**BOARD OF WATER SUPPLY
KA 'OIHANA WAI
CITY AND COUNTY OF HONOLULU**

September 26, 2024

Subject: Honolulu Board of Water Supply (BWS) Comments Related to U.S Navy
Presentation to the Commission on Water Resource Management
(CWRM) Meeting on September 17, 2024

2. On Slide 5 of the slide presentation, the Navy provided the following figure that depicts an interpretation of regional groundwater flow direction to the southwest.

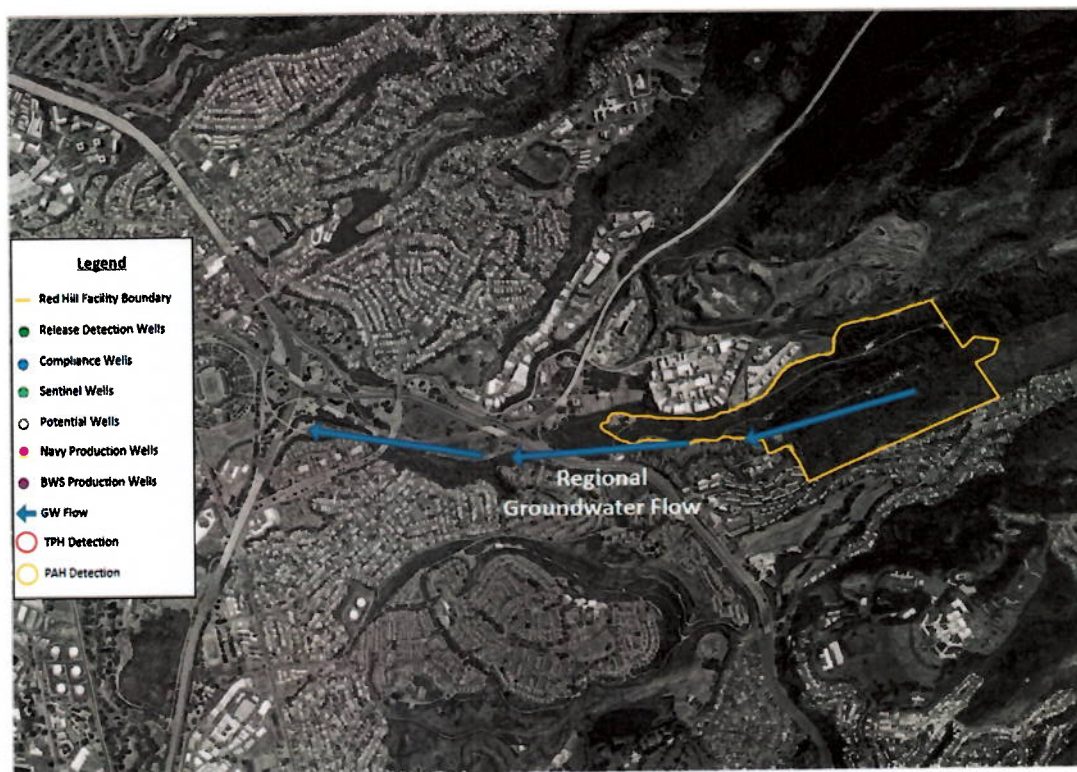
The Navy stated that this interpretation of regional groundwater flow direction is from a 2004 United States Geological Survey (USGS) report. The Navy did not provide a citation for this report, so the BWS is unable to review the source document, but this understanding of regional ground water flow direction is

incomplete and outdated, and the Navy is aware of this. In a letter from DOH to the Navy in 2019, the DOH provided the following graphic to depict the known ground water flow direction in the vicinity of Red Hill, which is also to the north and northwest even when Red Hill Shaft is pumping and Hālawā Shaft is off, which represents current conditions (DOH, 2019).

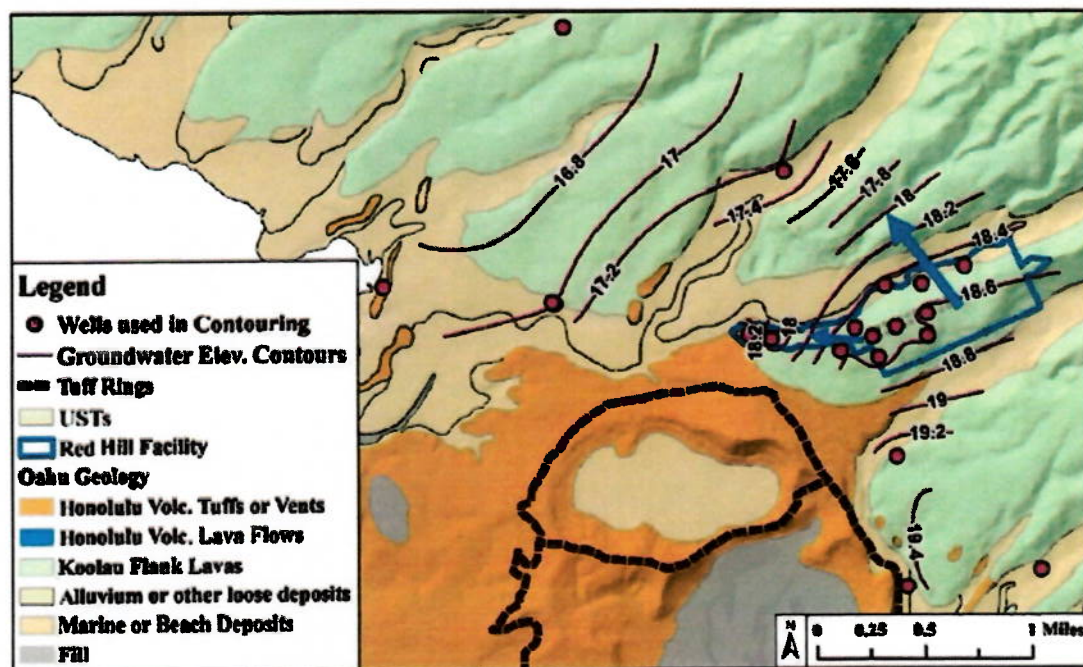
The DOH analysis in this letter outlined the following points of major disagreement between the regulatory agencies SMEs and the Navy regarding the Navy Conceptual Site Model (CSM) and initial numerical GWFM:

1. The disparity between the measured and modeled groundwater gradient along the axis of Red Hill Ridge and its implications for a reliable CSM and numerical groundwater flow model;
2. The absence of supporting field data for the CSM-assumed primary groundwater flow direction toward the southwest and away from Hālawā Shaft (one of the key receptors of concern); and,
3. Lack of consideration of groundwater flow toward the northwest without providing a compelling rationale.

The BWS cannot confirm whether and to what extent the above disagreements still exist because we have been unable to review the Navy's 2024 GWFM report. Our working

assumption is that these disagreements persist, because the Navy continues to hold out to the public a groundwater flow direction that is only to the southwest and does not appear to contemplate the component of groundwater flow that the BWS and regulatory agencies understand to be directed to the north and northwest, directly toward critical BWS groundwater pumping sources.
